Advisory No.: SER01420

Title: H10 Crane ATB

Product Series /Model: H10025 & H10034 Cranes

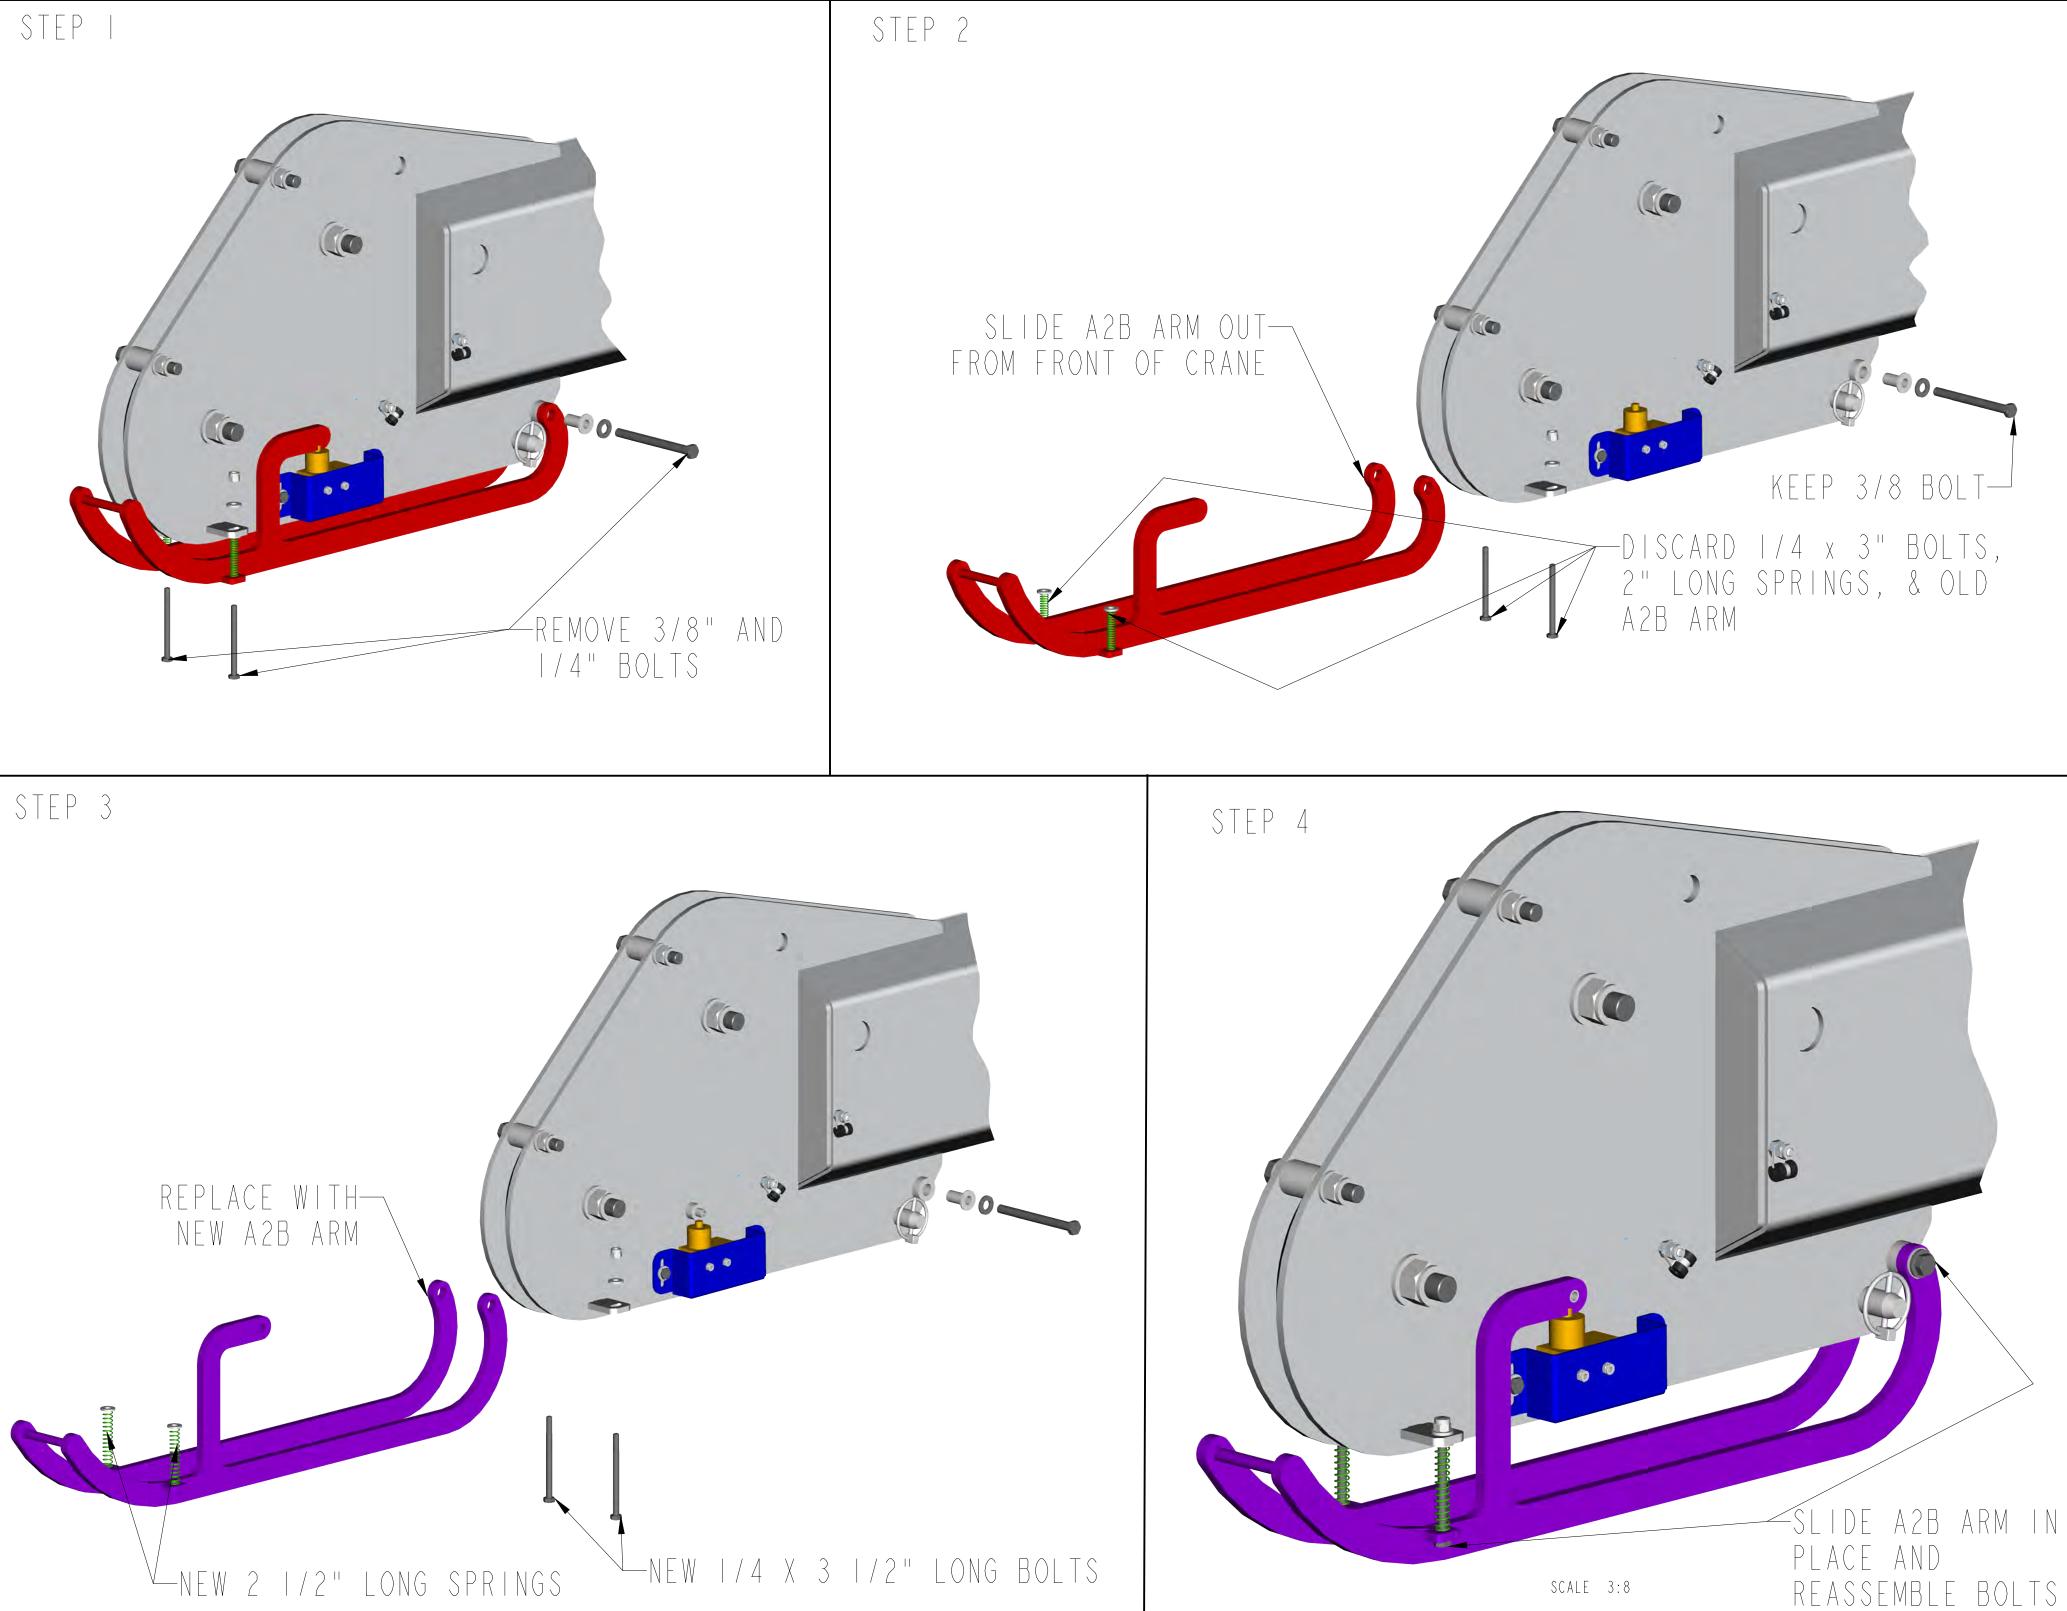
The anti-2-block system has been noted at certain angles, running full speed, with no load, that the load block can travel up and around the anti-2-block arm, which may allow 2-blocking.

- 1. Replace anti-2-block arm with new style.
- 2. Weld extension contact tabs to the load block.
